PUBLIC HEARING  
**ZONING  
CHANGE**  
RR to R5A  
CASE # 15ZON1015  
DATE: AUGUST 20, 2015  
THURSDAY 1:00 PM  
514 WEST LIBERTY STREET  
OLD JAIL BUILDING  
THIS PROPOSAL MAY BE REVIEWED  
BY THE BOARD OF ZONING APPEALS  
AND DEVELOPMENT CENTER  
440 S. 104 STREET, SUITE 108  
HOUSTON, TEXAS **574-6230**

TO: David Wagner, Planner & LDT Committee  
FROM: Teena Halbig, Immediate Past President FFEA  
6505 Echo Trail  
Louisville, KY 40299  
502 267-6883  
DATE: 7-22-15  
RE: 15ZONE2015 (Brentwood Commons at 10509 Bardstown Bluff Road; rezoning from R-R to R5a request)

**10509 Bardstown Bluff – Proposed Zoning from RR to R-5A impacting Floyds Fork Creek** This proposal impacts all who visit the park and will be seen by all Jefferson County Residents as well as outside visitors. This proposal has major impact to Floyds Fork environment, the future Rental Residents, as well as joining properties.

**Major proposal to move the 100 Year Floodplain**

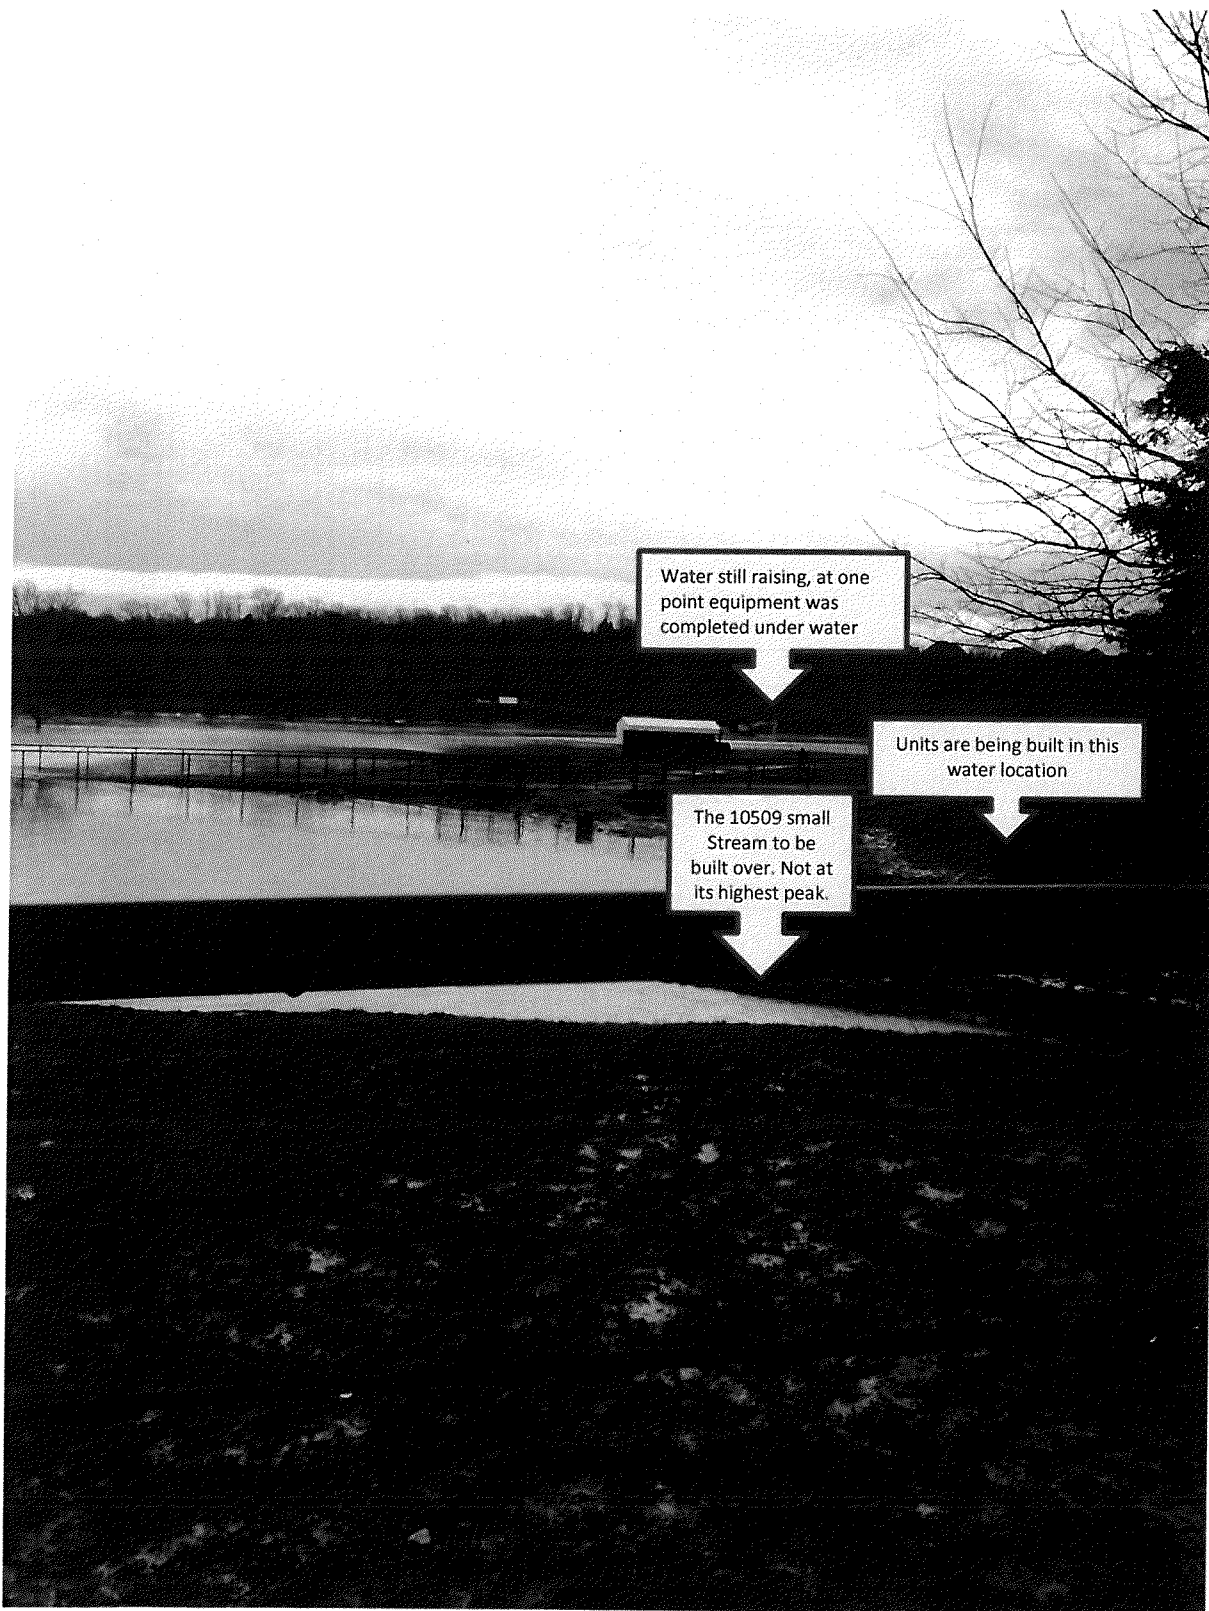
Below April 2015 picture is of the small stream on the 10509 property. The Parkland Bridge is in the background.

Water still raising, at one point equipment was completed under water

Units are being built in this water location
